WATER TOWER ROAD SCREEN WALL INVESTIGATIONS

Water Tower Road
Longs, South Carolina

Stantec Project No. 171015900

March 31, 2025

NO. 3 - COLUMN 13NM -
DROPPED PRECAST PANEL WITH
A CRACKED AND SPALLED TOP

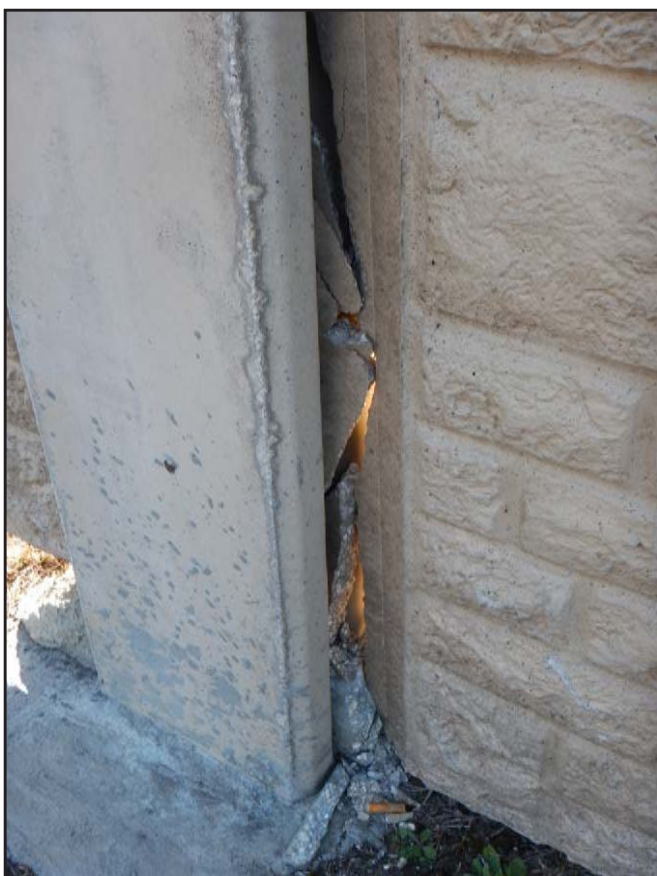
- 2C) In response to the attached email dated January 21, 2025, Stantec investigated one severely displaced wall panel at 3512 Club Course Drive, as shown in example photographs No. 1 through No. 11, and provided emergency repair recommendations as documented in previous Stantec Field Reports dated January 30, 2025 and March 11, 2025.

I enjoyed meeting you and Marie last week at the subject sound wall. Please confirm that Stantec is authorized to provide emergency repair details for the attached dropped wall panel at 3512 Club Course Drive, and Stantec will promptly provide repair details for pricing by Kennedy Richter Construction. Thanks.

DWG. NO.	TITLE
SHEET 1	COVER SHEET & GENERAL NOTES
SHEET 2	8' PERMAWALL 2.0 DIMENSIONS
SHEET 3	FOUNDATION, COLUMN, & PANEL DETAILS

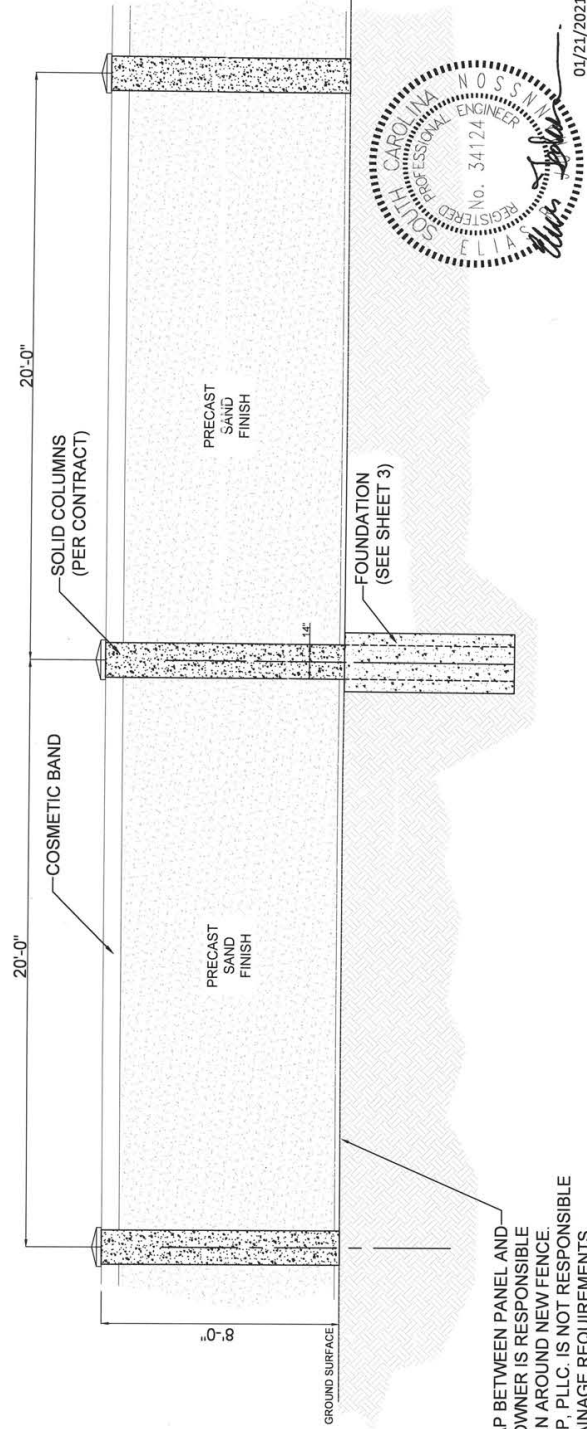
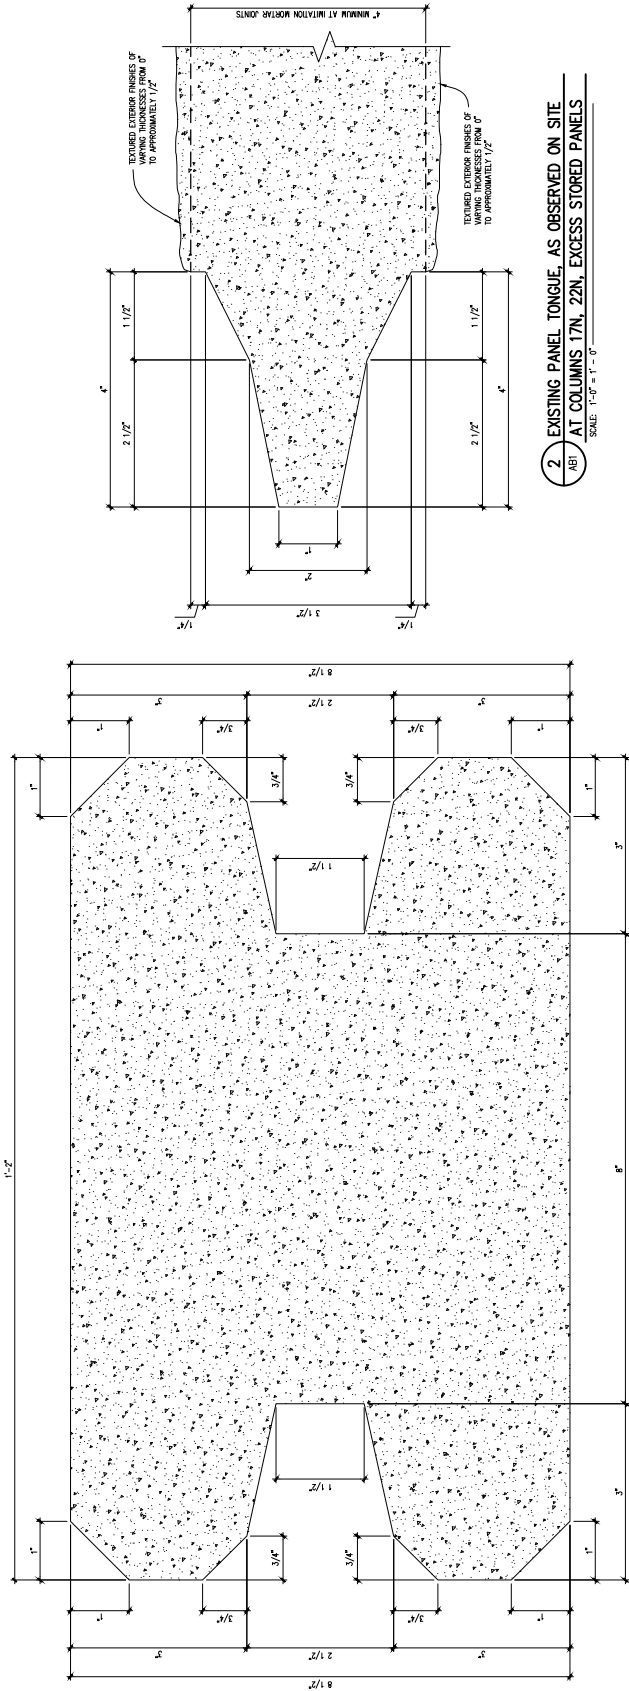
- 1) Wall panel "tongues" as detailed on Sheet 2 are too narrow to receive the specified reinforcing steel and provide 3/4" of concrete cover on each face, as required by the 2018 International Building Code and ACI 318-14.

- 2) Wall panel tapered "tongue" designs, combined with tapered column pockets, results in 1/2" of "play" at wall panel to column connections if columns are installed exactly at 20'-0" on center, and excessive "play," as shown on attached Sheet AB3, if columns are installed greater than 20'-0" on center.

- 3) No tolerances are specified for wall panel to column connections.
- 4) Column reinforcement specified in the Column Reinforcement Table on Sheet 3 references 8 feet high columns at 10 feet on center, in lieu of 8 feet high columns at 20 feet on center as specified on Sheet 2 and as constructed in the field.

Existing Column and Panel Connections as Measured on Site

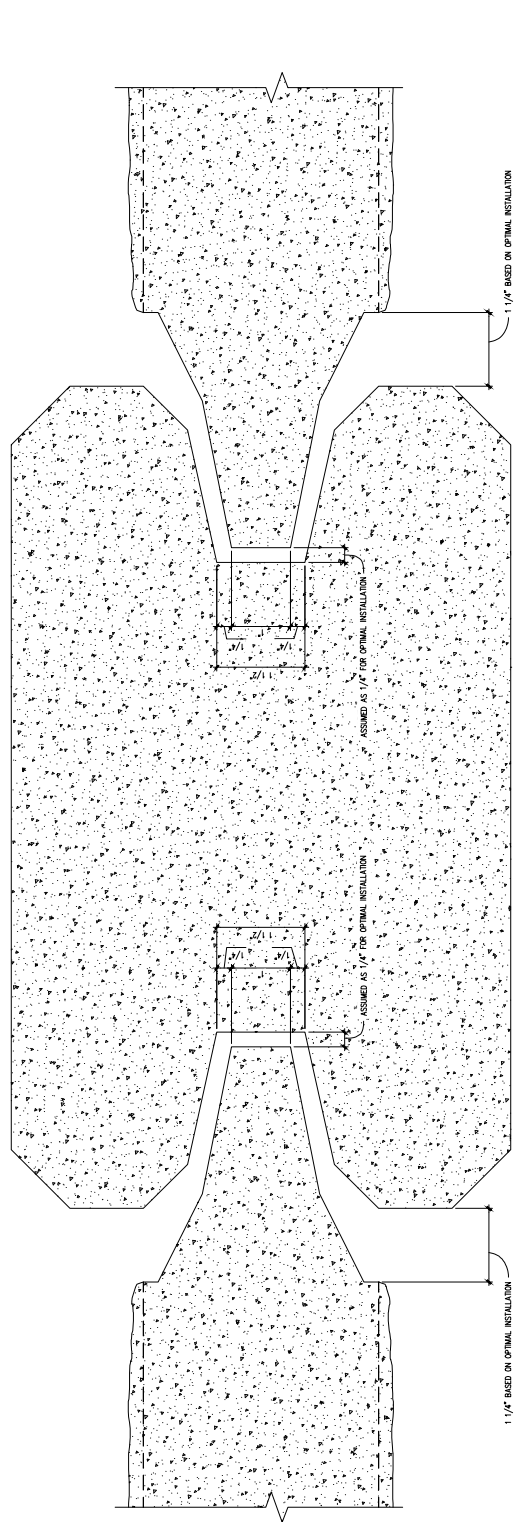
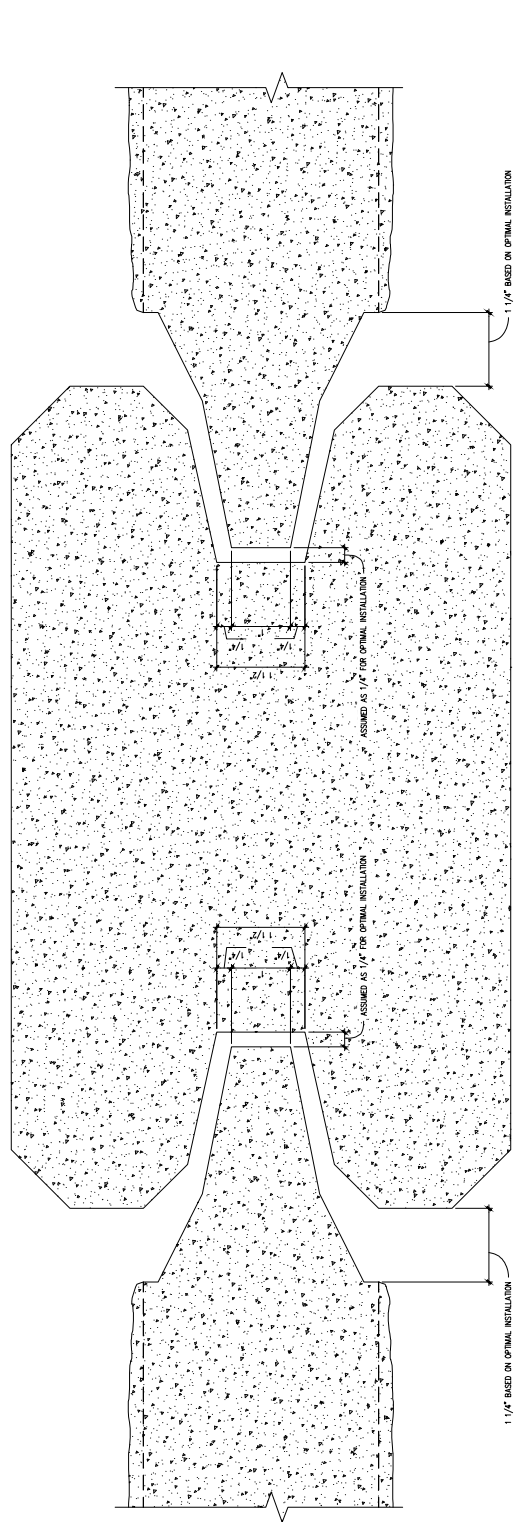
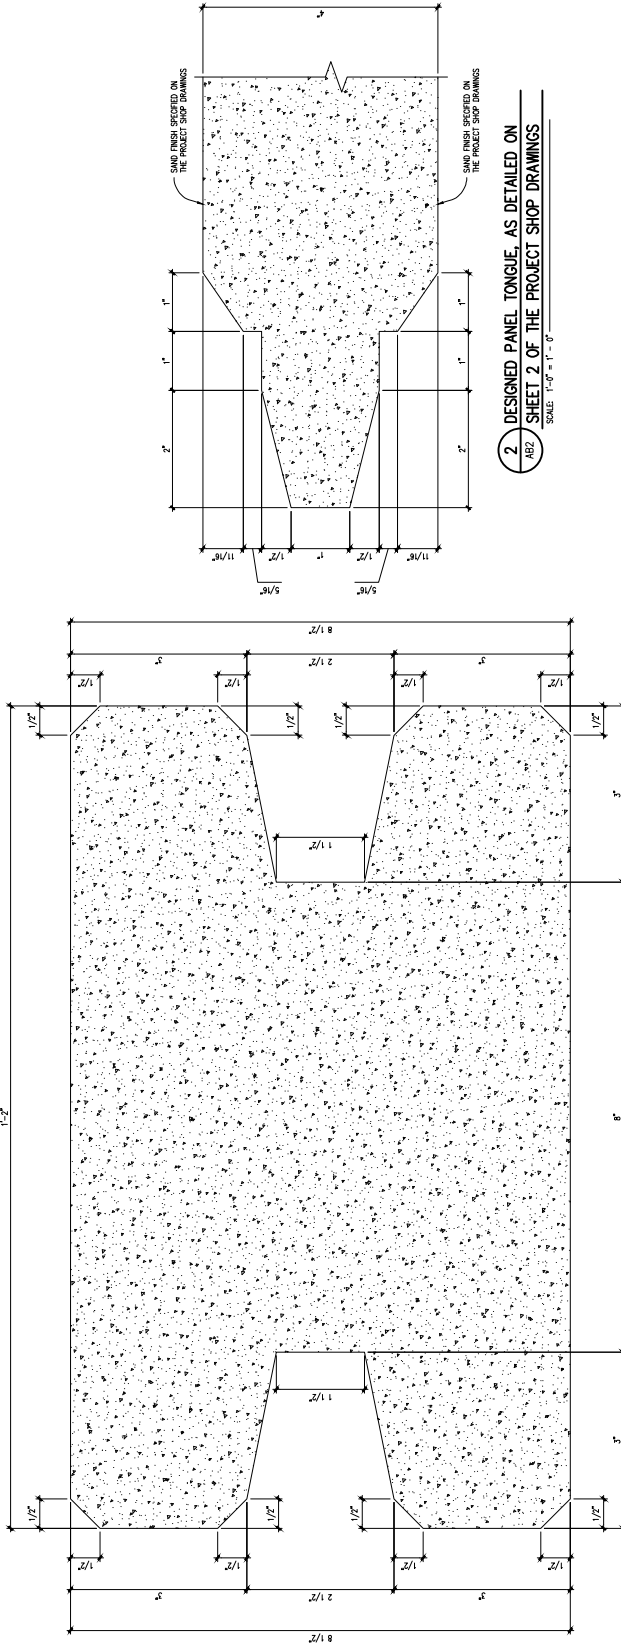
- 5C) Wall panel thicknesses vary from a minimum of approximately 4" to a maximum of approximately 5," due to textured wall finishes.
- 6C) Each end of each wall panel is formed with a "tongue," for seating into its supporting "H" column. Column dimensions and wall panel "tongue" dimensions were field measured at Columns 17N, 22N, and stored excess wall panels on site, as shown in example photographs No. 18 through No. 31. Field measured column dimensions and "tongue" dimensions are detailed on attached Sheet AB1 dated March 31, 2025.

- 15C) Numerous precast wall panels are insufficiently seated in precast "H" columns, as shown in example photographs No. 183 through No. 261 and compared to attached Sheet AB1 of field measured dimensions and Sheet AB3 of varying "play" at wall panel to column connections.

Designed Column and Panel Connections as Detailed on the Project Shop Drawings

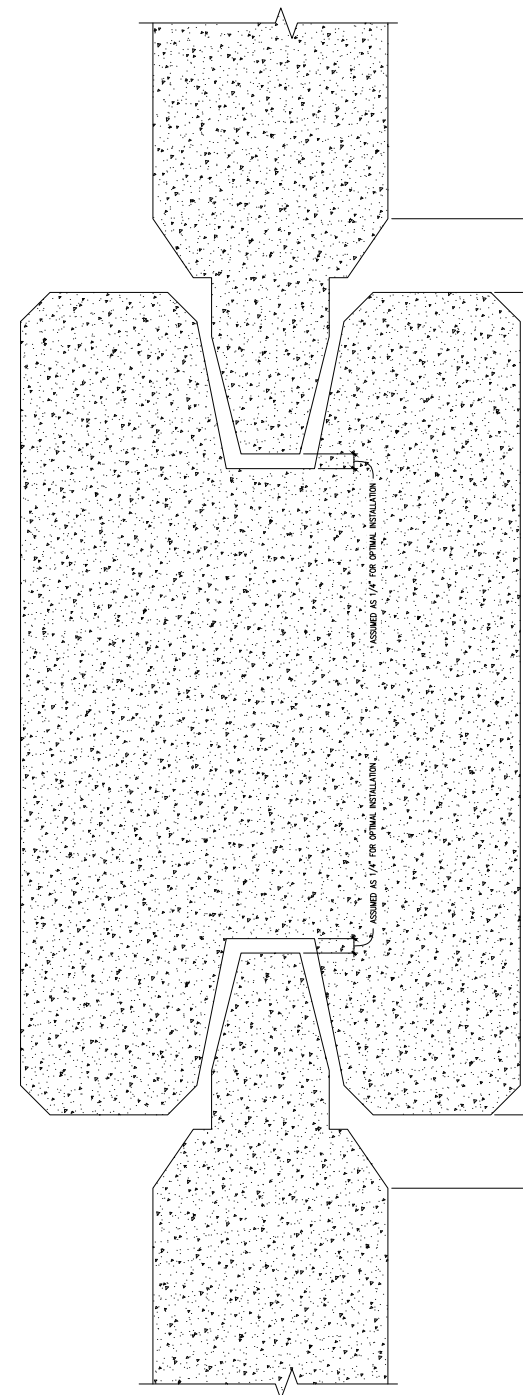
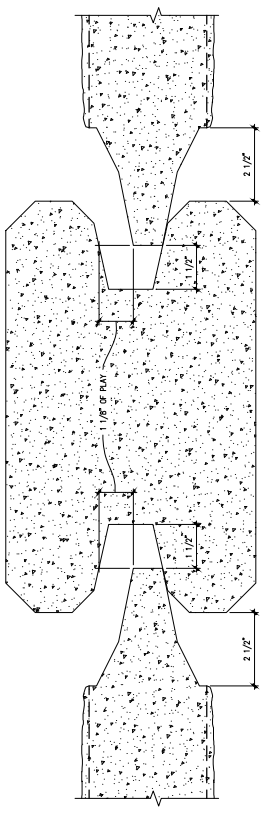
- 7C) Design column dimensions and "tongue" dimensions, as detailed on Mr. Johannsson's Construction Plans and Specifications, are shown on attached Sheet AB2 dated March 31, 2025. Field measured column and "tongue" dimensions on attached sheet AB1 are slightly different from design column and "tongue" dimensions on Sheet AB2. Field measured wall panel to column connections contain at least 1/2" of "play" if fully seated, and significantly more "play" if not adequately seated, as shown on attached Sheet AB3.
